SAFETY RECALL BULLETIN

NHTSA RECALL 19V923

AUTOCAR, LLC SAFETY RECALL ACTT-2001

Autocar has determined that a safety defect exists with the shift pad bracket on certain 2016-2019 model-year Xspotters.

Figure 1

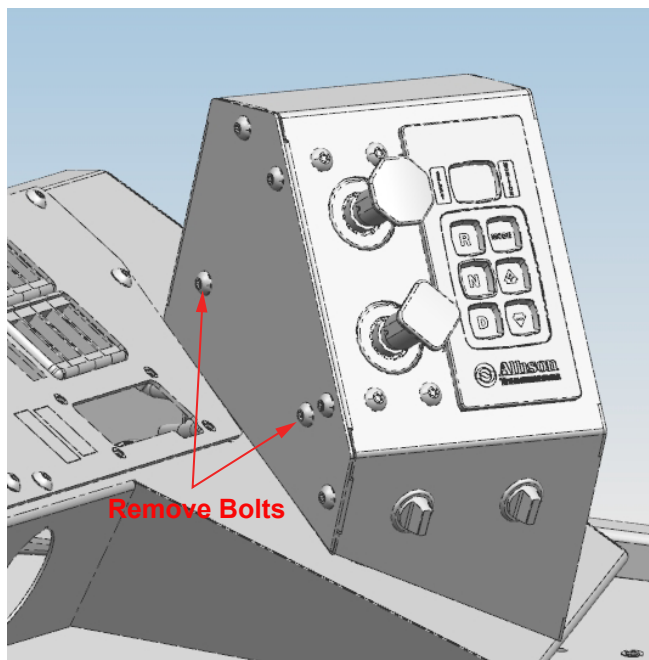
1. Ensure the boom is fully lowered.
2. Follow all lock out procedures and be sure to chock the wheels, drain the air tanks and disconnect the batteries.
3. Remove the 4 bolts from the shifter cover and set aside for reassembly (see *Figure 1* and *Figure 2*).

Figure 3

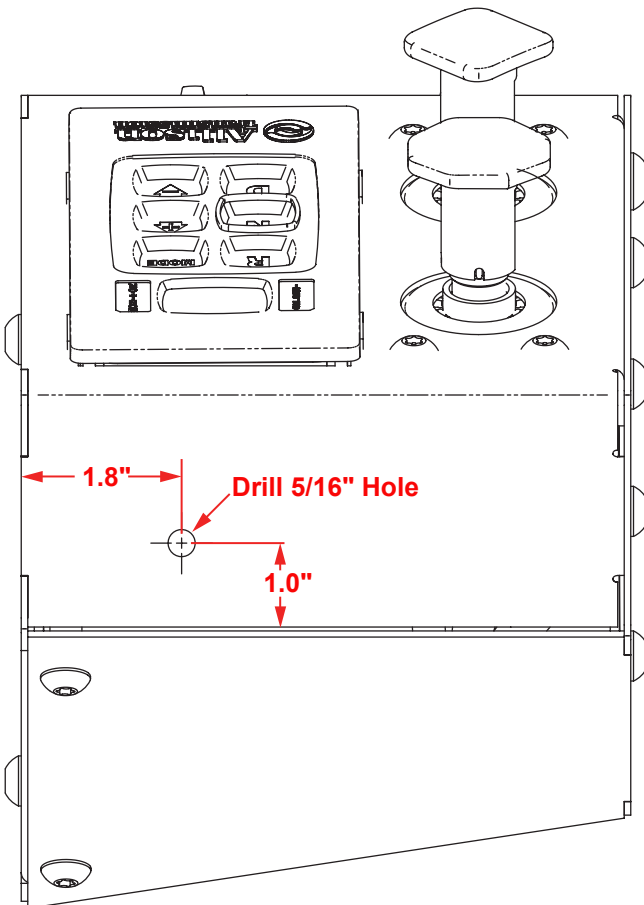
4. Drill a 5/16" hole into the top of the shift pad assembly, use caution to avoid passing through any deeper than required (see Figure 3).

Figure 4

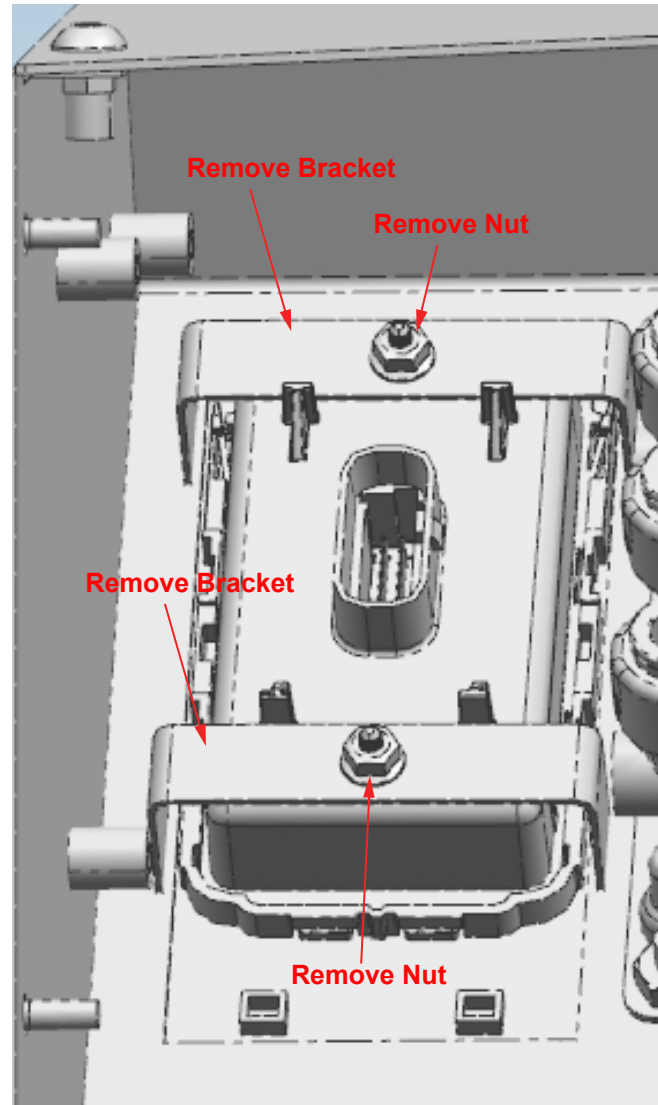
5. Remove (2) nuts and set aside for reassembly. (see Figure 4).
6. Remove the brackets holding the shift pad onto cover and discard (see Figure 4).

Figure 5

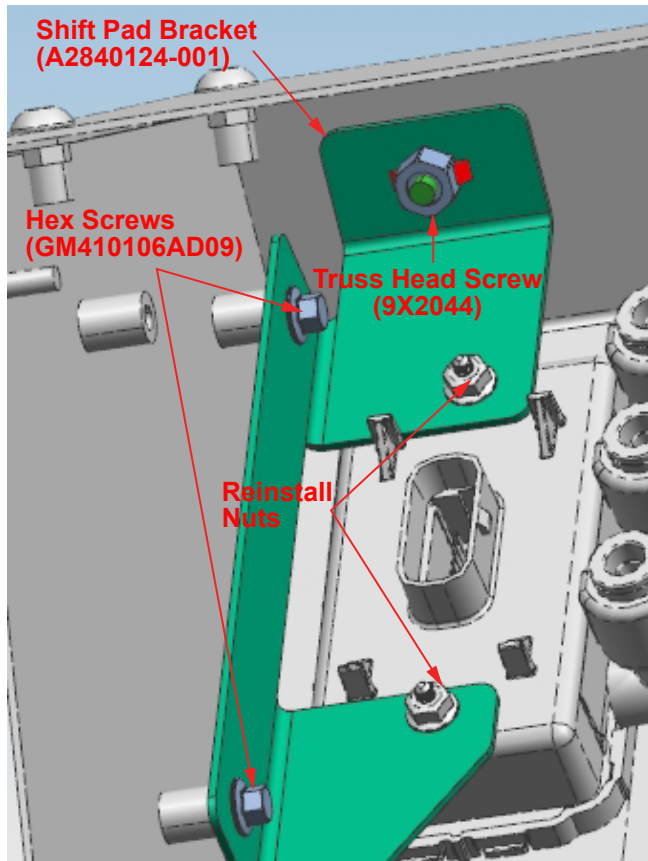
7. Using the (2) nuts that were set aside in step 5, install (A284012-001) bracket onto the shift pad inside cover and tighten to 13 in-lb of torque (see Figure 5).

8. Using (2) (GM410106AD09) hex screws provided in the service kit, secure the (A284012-001) bracket onto the shift pad inside cover and tighten to 75 in-lb of torque (see *Figure 5*).
9. Install the (9X2044) truss head screw, provided with the service kit, through the hole drilled in step 4 and tighten to 75 in-lb of torque (see *Figure 5*).

Figure 6

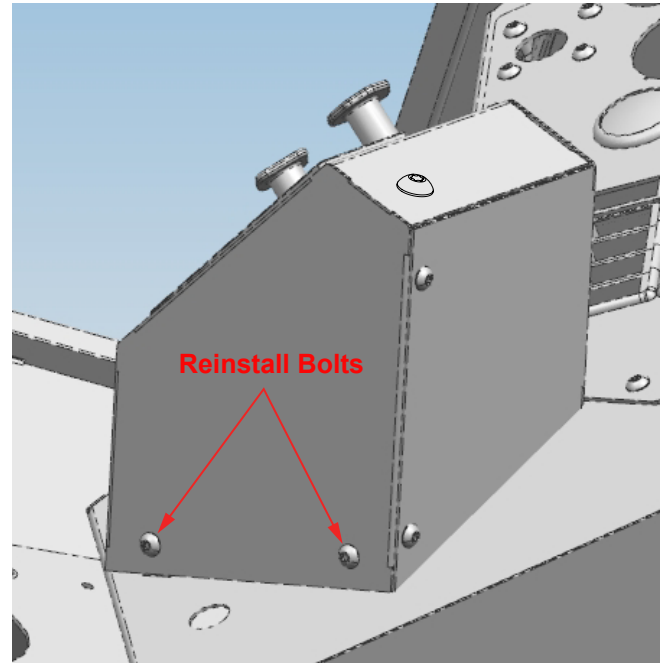
10. Reinstall (2) bolts that were set aside for reassembly in step 3 and tighten to 75 in-lb of torque (see *Figure 6*).
